DEPARTMENT OF TRANSPORTATION**Federal Aviation Administration****14 CFR Part 39**

[Docket No. FAA-2005-22481; Directorate Identifier 2004-NM-176-AD]

Airworthiness Directives; Bombardier Model CL-600-2B19 (Regional Jet Series 100 & 440) Airplanes**AGENCY:** Federal Aviation Administration (FAA), Department of Transportation (DOT).**ACTION:** Notice of proposed rulemaking (NPRM).

Figure 2. Outboard Flap Go/No-Go Criteria in Take-off Position"

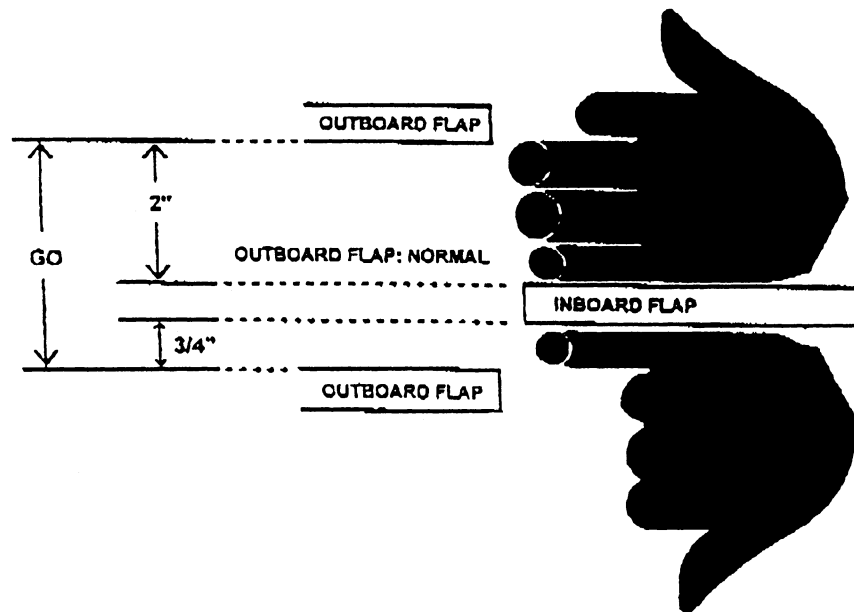
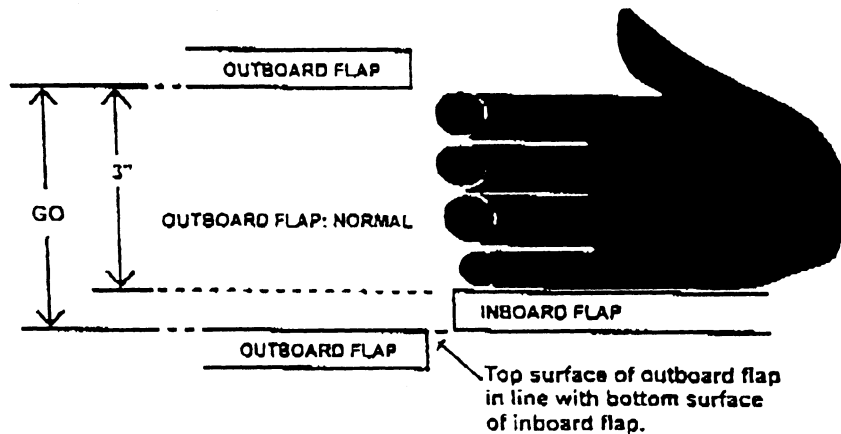
(1) Revise the Limitations Section of the FAA-approved airplane flight manual (AFM) to include the following procedures and Figures 1 and 2 of this AD. After accomplishing the actions in paragraphs (h) and (i) of this AD, remove the revisions required by this paragraph of this AD from the AFM.

IMPORTANT: *If the outboard flap position is outside the 'GO' range, as shown in figure 2., further flight is prohibited until required maintenance actions have been accomplished.*

(b) An external visual check must be accomplished to detect any twisting, skewing, or abnormal deformation of the flaps, using the information given in Figures 1 and 2.

Note 1: If the outboard flap position is outside the 'GO' range as shown in figure 2., further flight is prohibited until required maintenance actions have been accomplished.

If the outboard flap position is outside the "GO" range as shown below further flight is prohibited.

Whenever the outboard flap position indicator is outside the ‘GO’ range as shown in Figure 2, or whenever directed to do so by the Maintenance Procedure above, perform the following procedures:
